KANSAS GAS AND ELECTRIC COMPANY

KMLNRC 85-063
Re: Docket No. STN 50-482/OL
Subj: Supplemental Information Regarding
Chapter 17 of the Wolf Creek FSAR

ATTACHMENT A

Quality First Organization

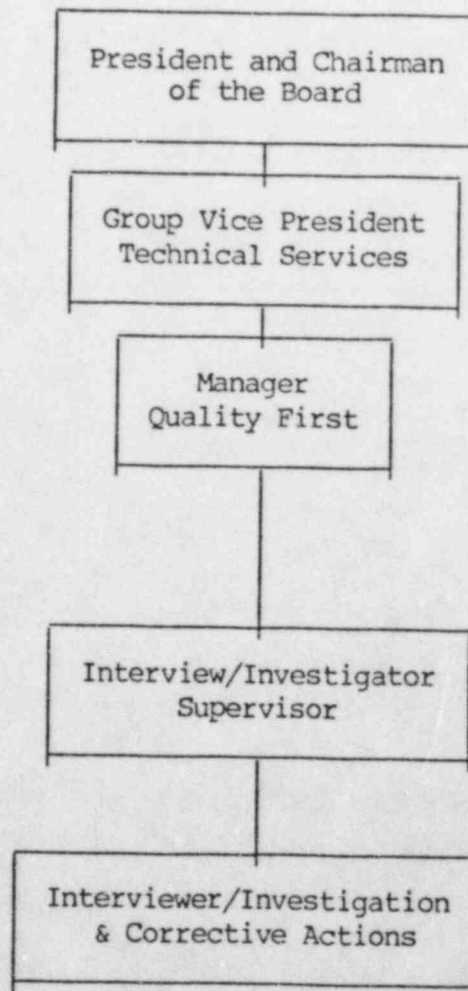
5. FSAR Section 17.2.1.11 introduces the Manager Quality First and the Quality First Program. This section of the FSAR states that the Quality First Program "provides an independent organization to investigate safety and quality concerns." Describe the program and the organization in more detail than given in 17.2.1.11.

The KG&E Quality First Program establishes the necessary administrative and investigative measures to ensure that all quality concerns related to safe plant operations, quality of work and compliance with project requirements are appropriately evaluated, investigated, dispositioned, verified and documented.

The overall objective of the KG&E Quality First Program is to:

- a. Assure that all WCGS employees, whether KG&E or onsite contractors, are made aware of the established channels/systems which they have available to state a quality concern.

- b. Ensure that quality concerns are evaluated and valid quality concerns are investigated, dispositioned, verified, and followed up in accordance with established procedural methods by an organization not directly responsible for the area of concern. Discrepancies are evaluated for reportability to the NRC per 10CFR50.55(e), Part 21, etc.

- c. Attempt to preserve the anonymity and/or prevent the harassment/discrimination of employees expressing quality concerns.
- d. Ensure that investigation results are made available to the individual(s) who initiated the quality concern provided they are known.

- e. Ensure all employees are made aware of and are provided an opportunity to discuss concerns with the investigative organization 1) prior to terminating employment at WCGS, or 2) anytime on a "walk-in" basis.

5. f. Establish a Quality Concern Investigation Status Report System to KG&E Management on an assigned frequency. Cognizant officials, managers, and regulators are kept apprised during the investigation.
